MFN 06-455
Supplement 1

Subject: Response to Portion of NRC Request for Additional Information
Letter Number 37 Related to ESBWR Design Certification
Application – Siting Issues – RAI Number 2.3-9 S01

**Response to Portion of NRC Request for Additional
Information Letter No. 37 Related to ESBWR
Design Certification Application**

RAI Number 2.3-9 S01

Figure 1 – Reactor Building Diffuse Source Plane Figure 1

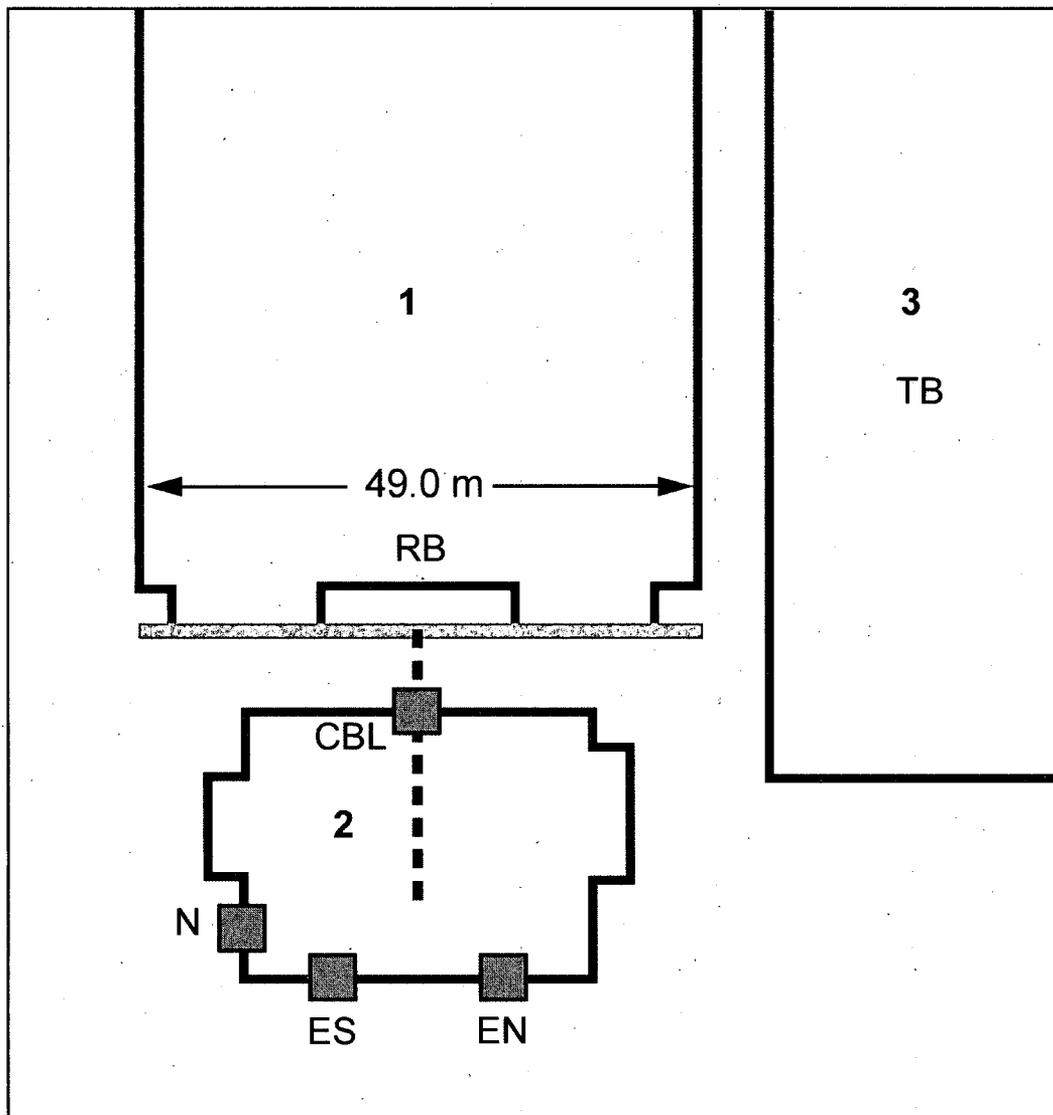
(i) Regulatory position 3.2.4.5 of Regulatory Guide 1.194 states that the height and width of the diffuse area source (e.g., the building surface) should be the maximum vertical and horizontal dimensions of the above-grade building cross-sectional area perpendicular to the line of sight from the building center to the control room intake. These dimensions should be projected onto a vertical plane perpendicular to the line of sight and located at the closest point on the building surface to the receptor. Please confirm that this is the approach used to calculate the diffuse area sources for the reactor building and turbine building leakage pathways. [[

While the previous approach to the diffuse sources was conservative, in response to this RAI the heights and widths of the diffuse sources have been refined as described in Regulatory position 3.2.4.5 of Regulatory Guide 1.194 for accuracy and consistency

with the guidance. The refined values for the diffuse source widths, areas, and initial diffusion coefficients will not change bounding ESBWR X/Q values, however, they will be listed in the associated ARCON96 inputs for use by future COL applicants for verification of the ESBWR X/Q values that are to be provided in DCD Revision 5 Appendix 2A. Diffuse source areas are established based on dominant intake location. The diffuse sources modeled for DCD dose analyses for the Control Room are depicted in the figures below.

Figure 2 - Turbine Building Diffuse Source Plane

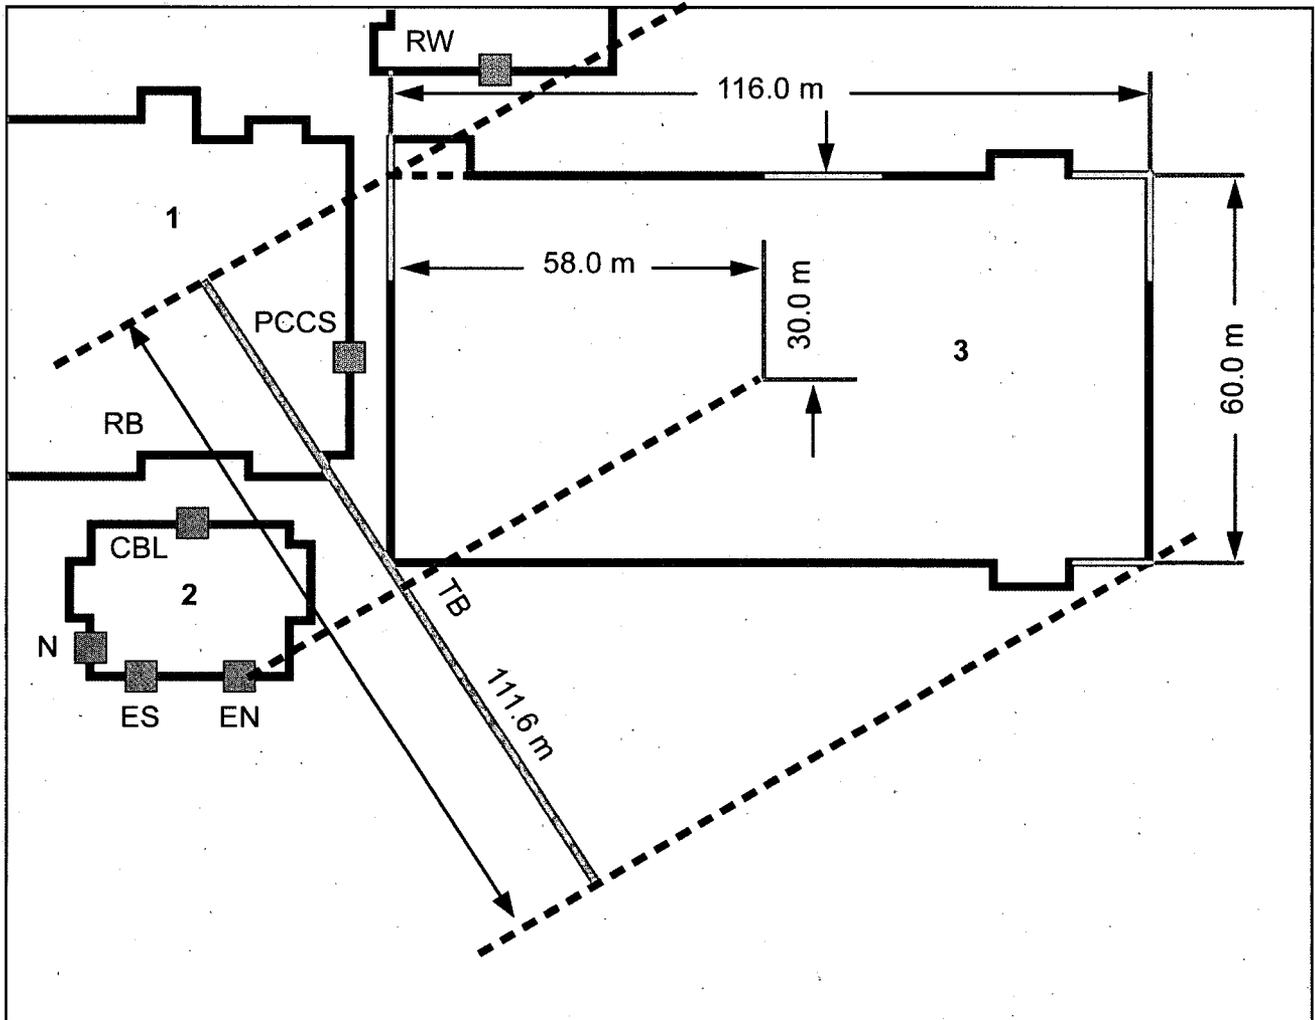
(ii) Since leakage is more likely to occur at a penetration, consideration should be given to the potential impact of building penetrations exposed to the environment. If the penetration release would be more limiting, the diffuse area source model should not be used. In particular, one of the assumed release pathways for the LOCA inside containment radiological analysis is MSIV leakage to the turbine building condenser. DCD Tier 2 Chapter 15.4.4.5.2.4 states that the two major points of release from the turbine building are expected to be (1) the truck doors at the far end of the turbine building and (2) the turbine building vent panels located midway on the turbine building on the side away from the reactor building. In contrast, the response to RAI 2.3-9 states that one of the release scenarios evaluated for MSIV leakage to the turbine building condenser is a diffuse release over the entire area of the turbine building. Please resolve this apparent conflict in the assumed MSIV leakage pathways to the environment by identifying all potential release pathways from the turbine building for all those accidents that have airborne releases in the turbine building and provide the appropriate ARCON96 source/receptor inputs.

During preparation of this RAI response, it was confirmed that the TB vent panels are not part of the ESBWR design. The text in DCD Subsection 15.4.4.5.2.4 was incorrectly stated. The TB truck doors have been included in Figure 2A-1 and in Table 2A-2, and the bounding TSC receptor (TSCW)/ TB truck door pair has been included in Table 2A-3.

GEH agrees that if the point source release from a penetration would be more limiting, the TB diffuse area source model should not be used. It has been assumed that the ESBWR Turbine Building should be conservatively treated as a diffuse source because preliminary analysis of the Turbine Building using ARCON96 indicated that the diffuse source model was more limiting than releases from the TB truck doors. The validity of the TB diffuse source model can be demonstrated by performing ARCON96 runs for point sources in the TB at those locations. Since Appendix 2A directs the COL applicant to model all source/receptor pairs listed in Table 2A-2 in order to ensure that the X/Q values provided in DCD Tier 1 Table 5.1-1 and Tier 2 Table 2.0-1 are bounding, the table of ARCON96 inputs includes parameters for the TB truck doors.

Figure 2A-1. Potential Radiological Sources and Receptors for the ESBWR Control Room
(see next page for explanation of designations used on figure)

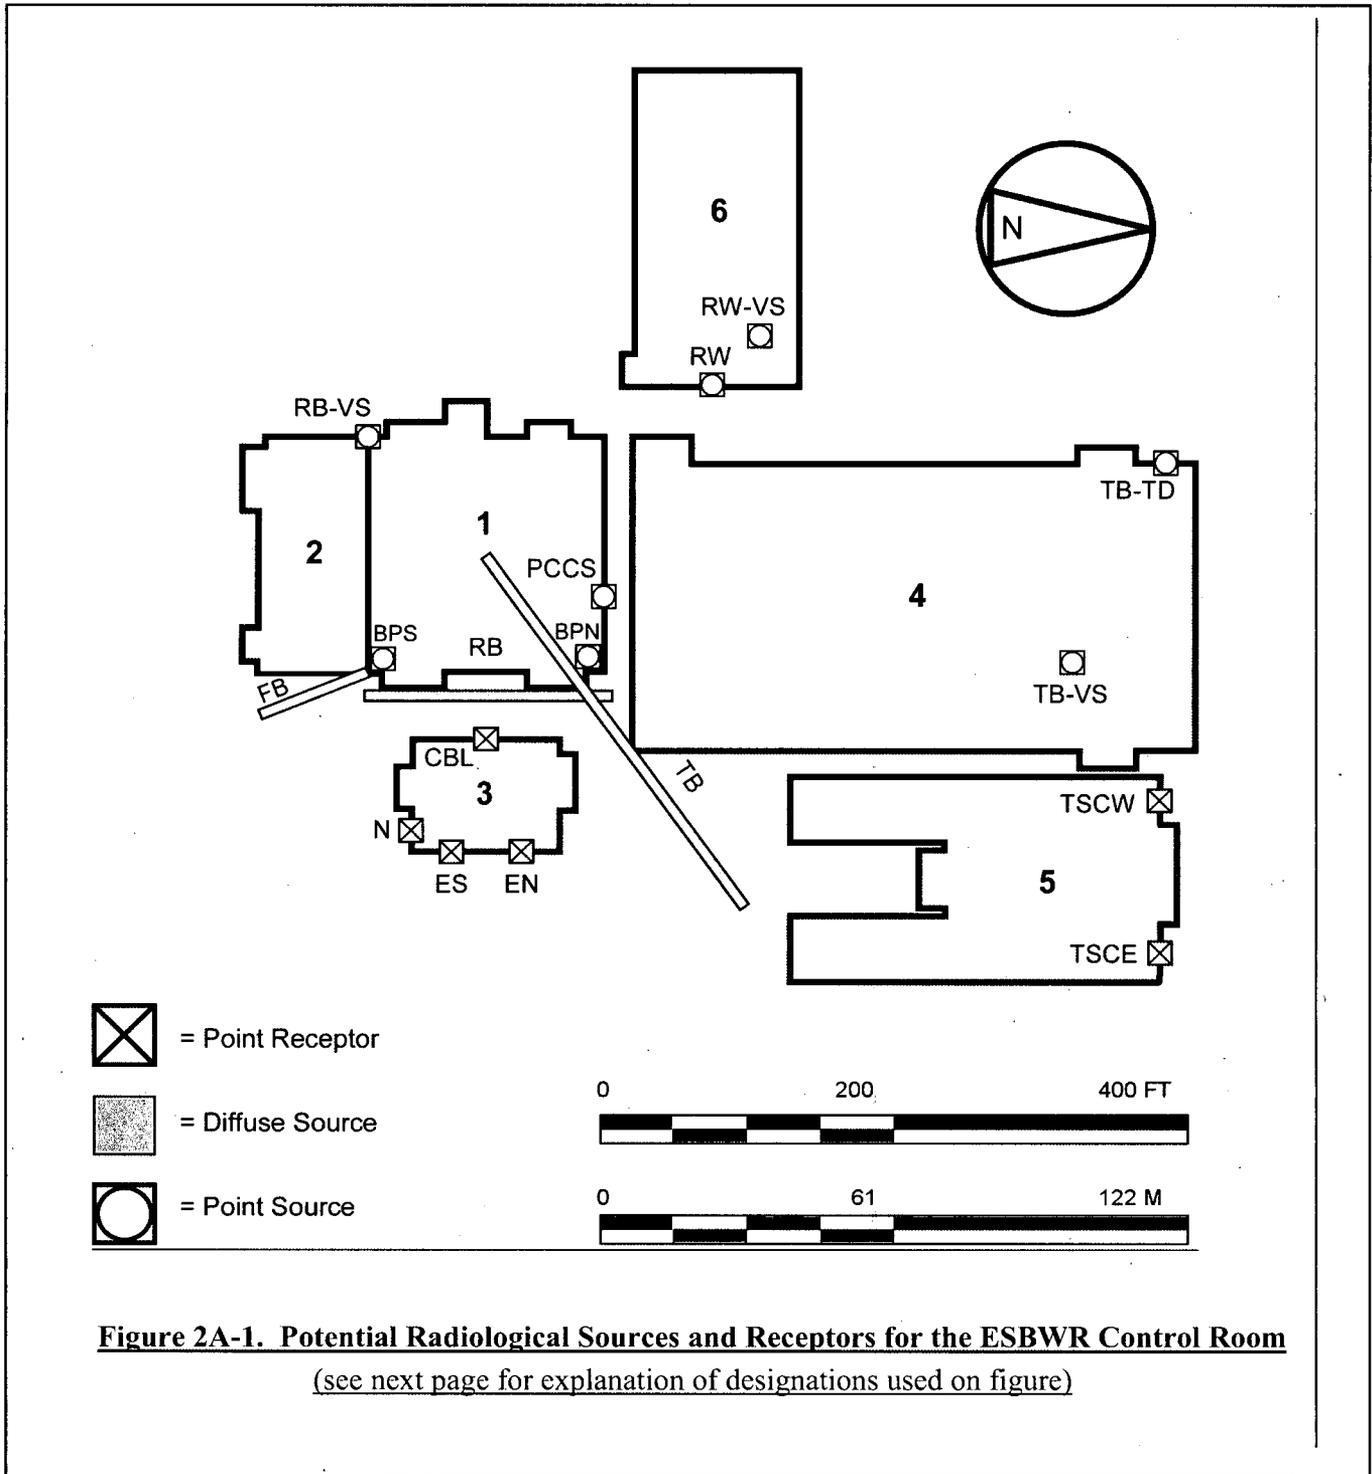
- (i) Please provide one scaled general arrangement drawing showing all potential release pathways and receptors. Plant north should be indicated on this drawing.*

A scaled drawing showing all potential release pathways and receptors for use with Control Room radiological dose evaluations indicating ESBWR Plant North based on General Arrangement Drawing in Figure 2A-1 of DCD will be provided in Revision 5 of the DCD in Appendix 2A.
